Appl. No. 10/696,513
Group Art Unit: 3636
Amdt. Dated November 23, 2004
Reply to Office Action of August 25, 2004

Amendments to the Drawings:

Appl. No. 10/696,513
Amdt. Dated November 23, 2004
Reply to Office Action of August 25, 2004
Annotated Sheet 1 of 2 Showing Changes

FIG. 1

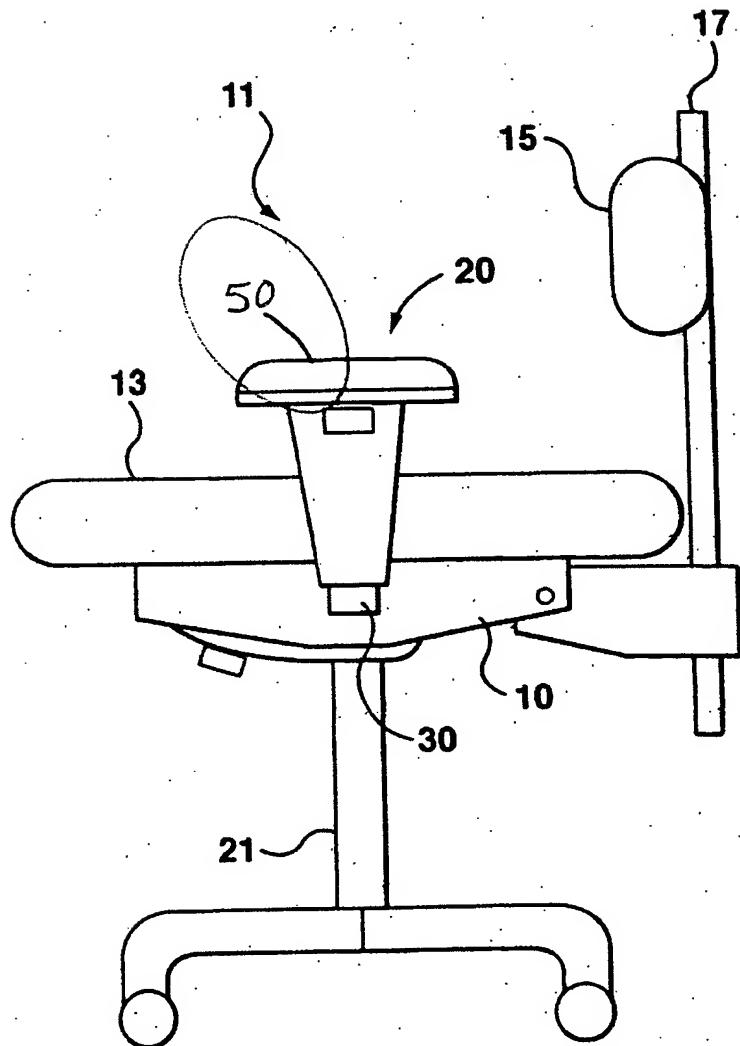
Paragraph 23 has been amended to correct the figure reference at which the armrest pad is seen and figure 1 has been amended to include the reference numeral for the armrest pad.

Applicant requests permission to substitute the enclosed drawing sheets containing figures 1, 2, and 8. A copy of the original drawings sheets containing these figures is also enclosed circling the amendments made in the replacement figures.
